Hurricane Planning Commission Meeting Agenda

February 12, 2026
6:00 PM

Agenda Date:	02/12/2026 - Planning Commission
Application Number:	GPA26-01
Action Type:	Legislative
Applicant:	Adam Nielson
Agent:	Karl Rasmussen
Request:	Request for a General Plan Amendment from Single Family to Multifamily.
Location:	1015 N 200 W
Zoning:	R1-10
General Plan Map:	Single Family
Recommendation:	Deny
Report Prepared by:	Fred Resch III

Agenda Date:	02/12/2026
Application Number:	ZC26-01
Type of Application:	Zone Change Application
Action Type:	Legislative
Applicant:	Adam Nielson
Agent:	Karl Rasmussen
Request:	A Zone Change from R1-10 to RM-1
Location:	1015 N 200 W
Zoning:	R1-10
General Plan Map:	Single Family
Recommendation:	Deny
Report prepared by:	Fred Resch III

ZONE CHANGE MAP FOR:
ADAM NIELSON
PARCEL H-3-1-27-2106
LOCATED IN SECTION 27, T41S, R13W, S.L.B.&M.
HURRICANE CITY, WASHINGTON COUNTY, UTAH

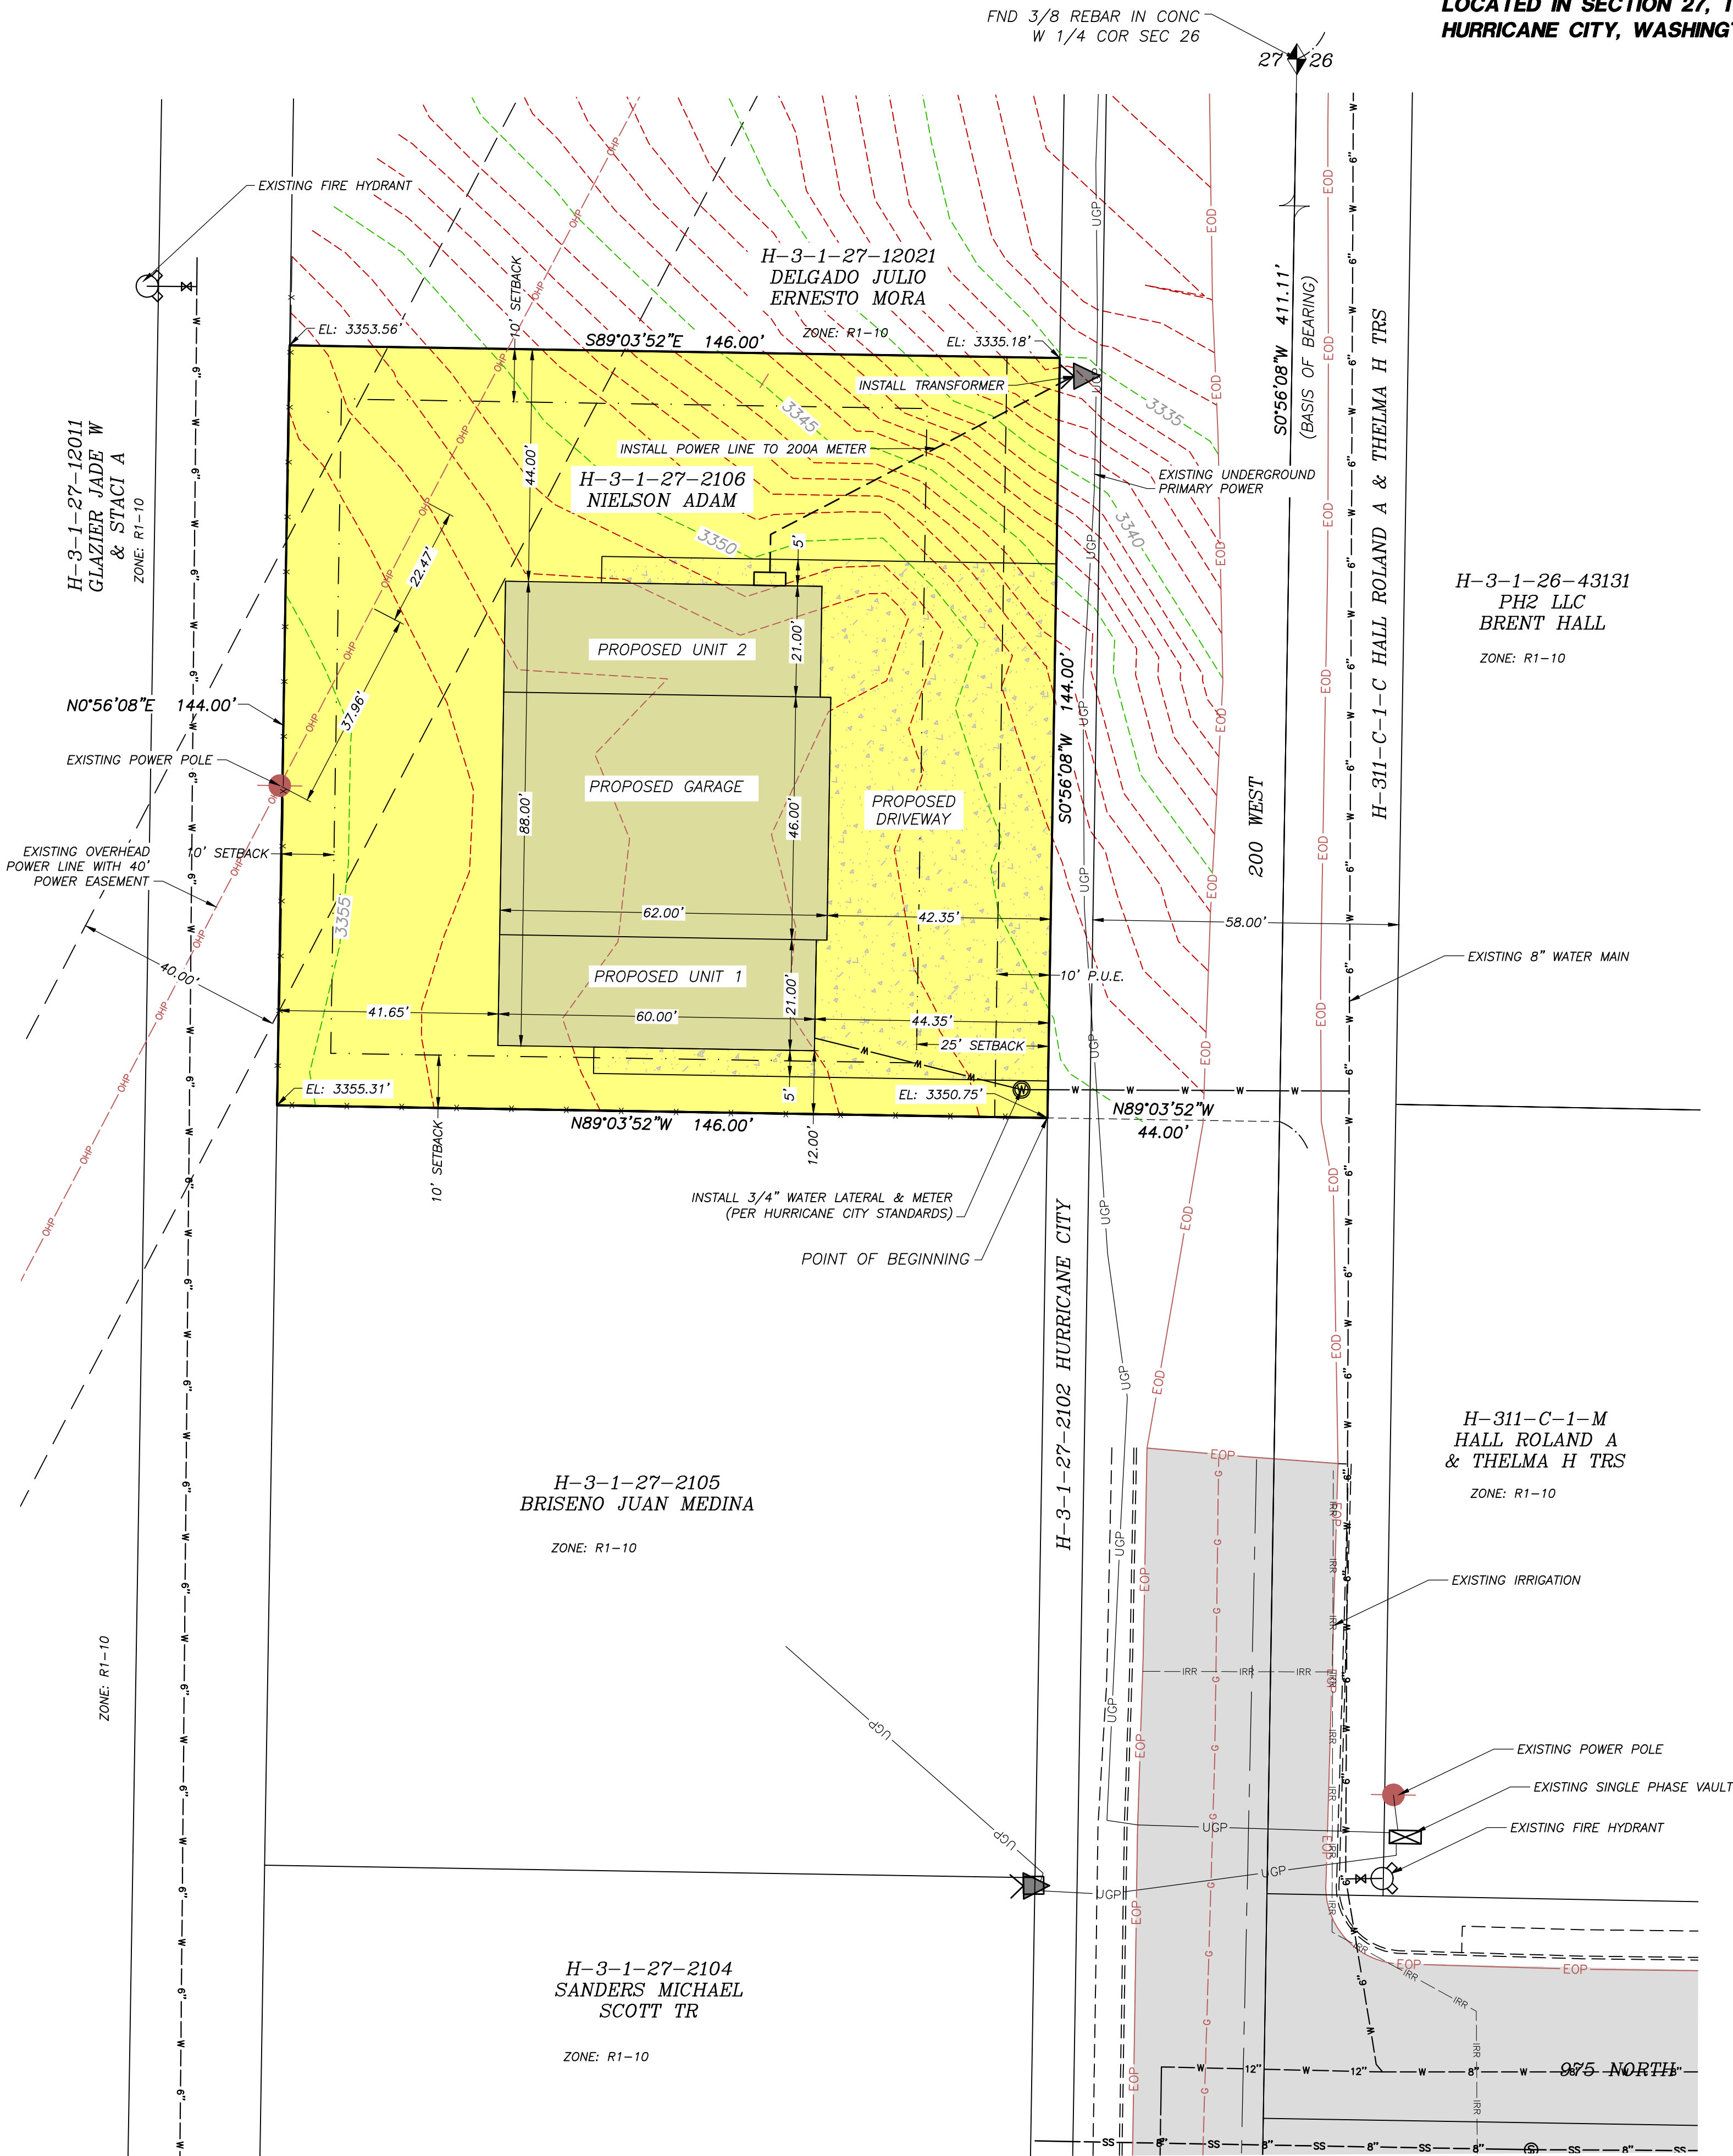
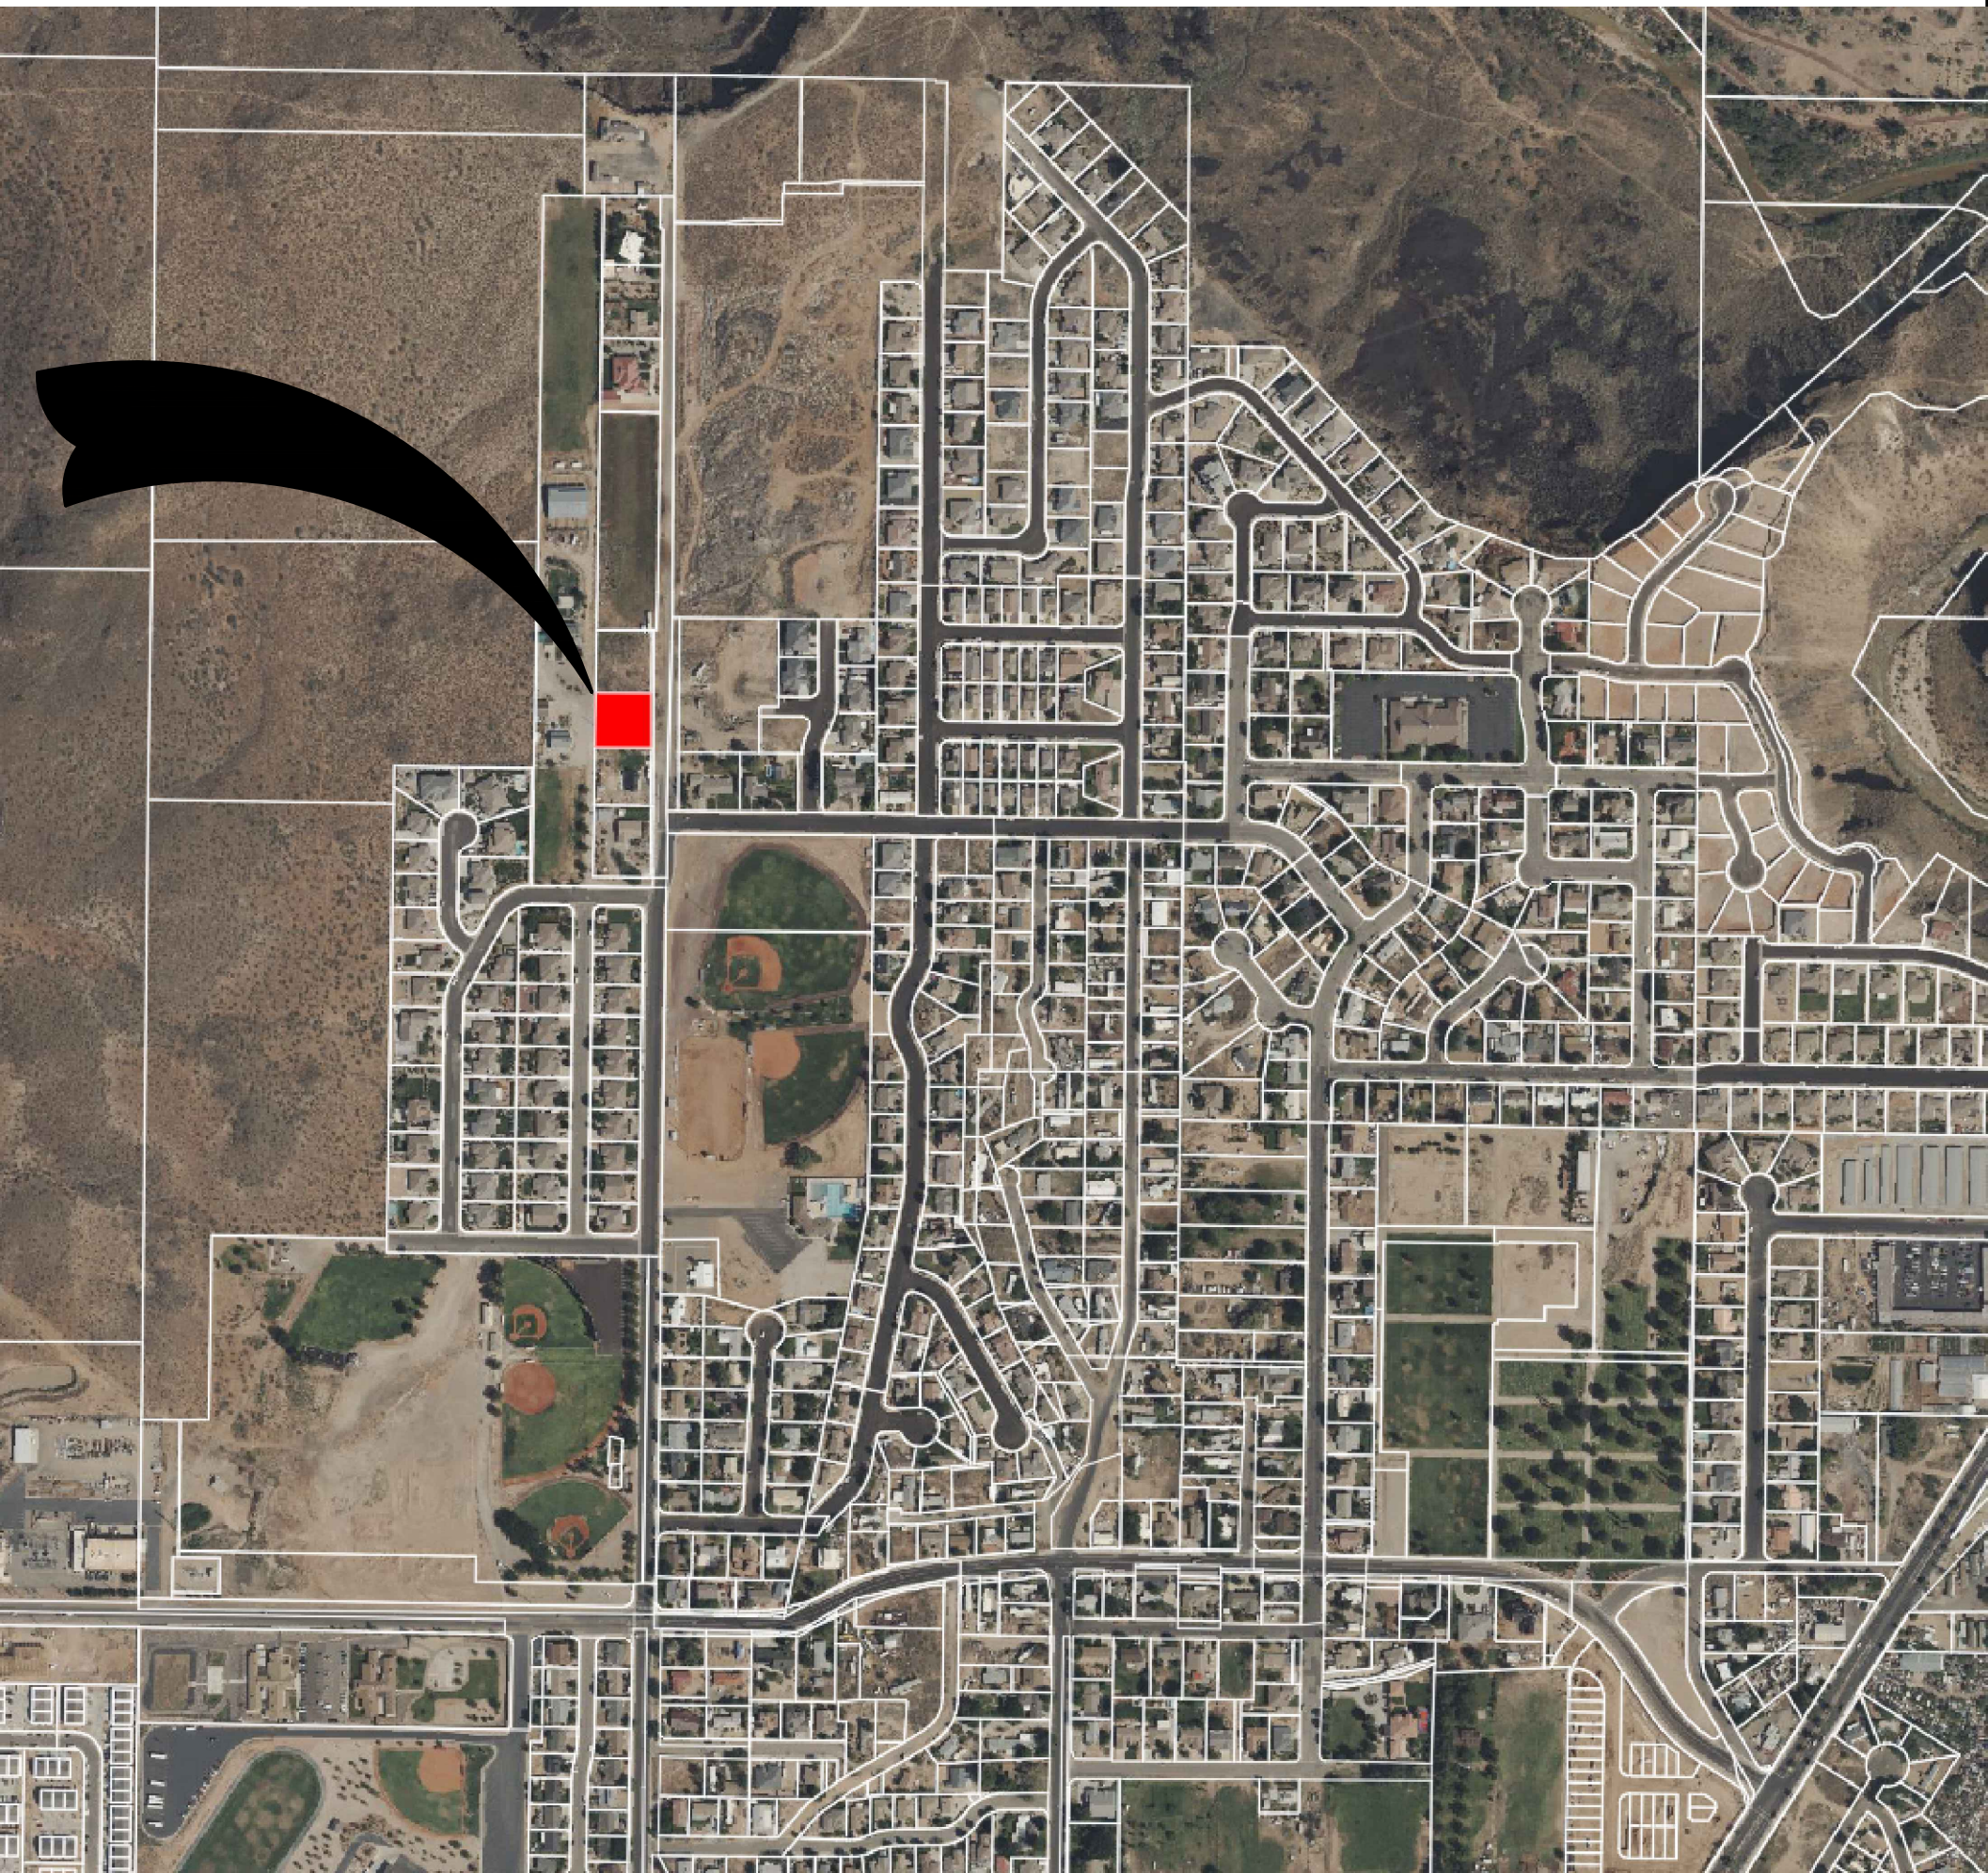
The applicant is seeking a zone change from Single Family Residential R1-10, one unit per 10,000 sq ft, to Multiple Family RM-1 for a 0.48-acre lot for the purpose of building a duplex on the property. The lot is located along 200 W north of the existing improvements on an unimproved road. The applicant has stated they would like to build a duplex for family members. Staff has informed the applicant of the Accessory Dwelling Unit (ADU) ordinance and how it might accomplish their goals for this property without the need for a zone change or the construction of a multifamily duplex. Notwithstanding, the applicant has elected to proceed with the requested zone change.

Response: It should be noted that the applicant has also applied for a General Plan Amendment, and this report's analysis is based on the current General Plan designation of the property and surrounding area. The General Plan Map designates this area as "Single Family", which advises densities consistent with R1-15, R1-10, R1-8, and R1-6. The proposed Multiple Family RM-1 zone does not comply with the general plan's Single Family designation for the site. Rezoning the property would create an inconsistency between zoning and the general plan where consistency currently exists. Although, it is recognized that the general plan is advisory in nature and not binding, and the City Council ultimately has discretion to approve a zone change that does not conform with the general plan if they deem the degree of inconsistency to be minimal or of no consequence. Nevertheless, it is not an advisable land-use practice to create inconsistencies between zoning and the general plan. Rather, it is generally expected that zone changes be approved in cases that maintain or improve consistency.

Response: The area is sparsely developed, with the majority of the surrounding area being undeveloped. There are larger lots with agricultural use in the area and any multifamily use would not be harmonious with the low-density agricultural and single family uses in the area.

Response: The surrounding area remains largely undeveloped and lacks fully constructed public infrastructure, including improved roadway access, drainage facilities, and utility extensions. Additional

Response: Some public facilities and services are in the vicinity while others are not. 200 W is not fully improved and the applicant does not control enough property to make it acceptable. While Ash Creek Special Service District finds a septic system acceptable for this project, it is poor planning practice to allow increased density in an area with no gravity sewer. See JUC comments below.

Engineering: 200 W (a master planned major collector with a trail on its west side) is a substandard road and the water main in 200 W is (was) substandard. Sage Pointe Phase 5, a development currently under construction northeast of the proposed zone change, has committed to replace the water main and construct curb, gutter, and sidewalk on 200 W's east side and pave 32' of asphalt across the proposed zone change's frontage. Additional right of way is to be secured from the Halls (per a commitment on document #20080003353). The exact timing is uncertain.

Fire: Utility plan must be submitted and approved.

The applicant has stated that they want two units for an affordable living arrangement for family or friends. The current Single Family Residential R1-10 zoning would allow for a single-family home with an ADU, which would also accomplish the applicant's goal of having two units. The proposed floor plan would have to be amended so that one unit was clearly "subordinate" to the other as the city code requires. Staff strongly recommends that the applicant pursue this route instead.

1. The application does not comply with the general plan's Single Family land-use designation of the area, and would create a new inconsistency with the General Plan.
2. The neighborhood and surrounding development is sparsely developed single-family homes. A single, Multiple Family RM-1 lot with a duplex would be out of character with the single-family nature of the neighborhood and vicinity.
3. The proposed amendment may have an adverse impact on the surrounding properties.
4. Services are largely inadequate to serve the area and proposed project.

Recommendation: The Planning Commission should review the requested zone change based on standards within the Hurricane City Code, and also consider any public comments. Based on the findings that the proposed zone change does not comply with the General Plan, along with the potential for future construction of a duplex that could be out of character with the surrounding single-family homes, staff recommends that the Planning Commission send a recommendation of denial to the City Council. Staff recommends the applicant apply to build a single family home with an ADU to accomplish their goals for the property.
